## Planning Commission Staff Report

<b>Project Type:</b>	Site Development Plan
<b>Meeting Date:</b>	July 9, 2018
<b>From:</b>	Cassie Harashe, Planner 
<b>Location:</b>	14905 Clayton Road
<b>Description:</b>	<b>Mobil Mart at Baxter and Clayton (Brite Worx):</b> A Site Development Plan, Landscape Plan, Lighting Plan, Architectural Elevations and Architect's Statement of Design for a 1.72 acre tract of land zoned "PC" Planned Commercial District located on the western corner of the intersection of Clayton Road and Baxter Road.

The request is for a Site Development Plan, Landscape Plan, Lighting Plan, Architectural Elevations and an Architect's Statement of Design for a new 4,020 square foot stand-alone carwash facility at 14905 Clayton Road. The proposed building is to be constructed of EIFS and brick veneer with a stone base and a clear acrylic roof system. Accents include metal fascia, exposed steel ribbing, and clear glass windows. The subject site is zoned "PC" Planned Commercial District and is governed under the terms and conditions of City of Chesterfield [Ordinance 2977](#).

Figure 5: Color Elevations

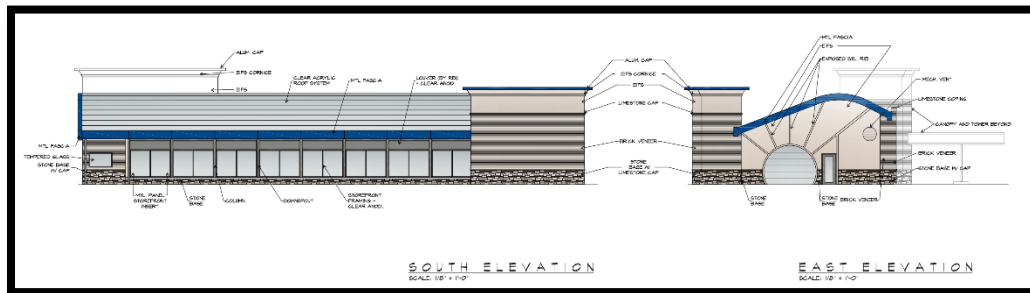
Please require that they reduce, if not eliminate, the gaudy bright blue trim. Add more brick similar to those used in the commercial buildings on the south west corner of Clayton and Henry. The rendering of the Clayton and Baxter Briteworx does not reflect what the signage will look like and where it will be located. That is an important factor that needs your review.

Figure 6: Screening Wall & Fence Locations

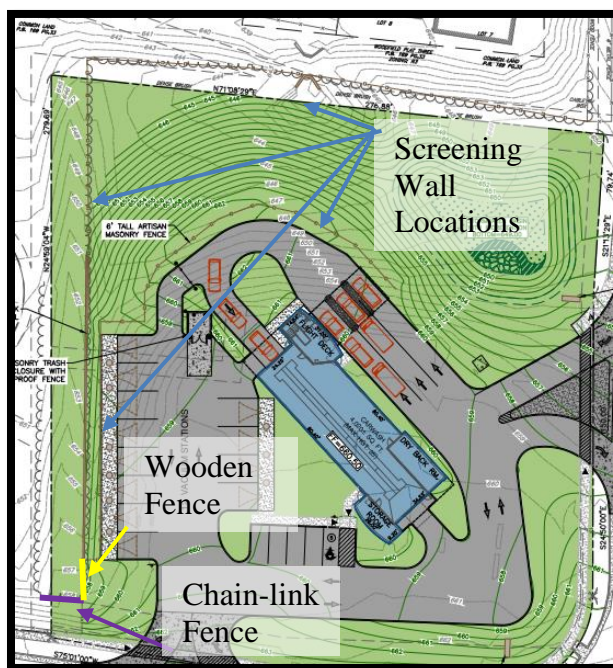
Per the requirements of Ordinance 2977, the site should have an artisan concrete screen wall along the western edge of the vacuum station that continues to wrap around the northern side of the drive aisle around the development. The Ordinance also has a requirement that an artisan concrete wall be installed along the northern property line. The Site Development Plan shows the required wall, along with an artisan concrete wall that connects the northern wall to where the wall turns at the vacuum stations, essentially providing a continuous wall along the western and northern property lines. The locations of these walls are indicated by blue arrows in Figure 6.
